Technical Service Bulletin

20 MIL on (DTC P045600 - EVAP system leak detected NVLD (very small leak))

20 15 54 2035073/12 October 29, 2015. Supersedes Technical Service Bulletin Group 20 number 15-52 dated October 28, 2015 for reasons listed below.

Figure 7. Plastic port extending past the grommet (A) causing installation issues (B).

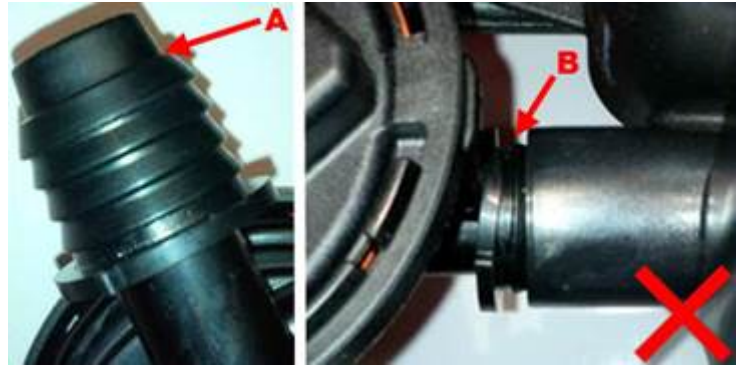
- An incorrectly-installed sensor and grommet (Figure 7) can cause an EVAP leak and repeat failures. Issues can occur when the NVLD switch is pressed too far into the canister, then pulled back out in an attempt to align the NVLD switch with the mounting holes. Do not apply any lubricant between the sensor and the grommet.
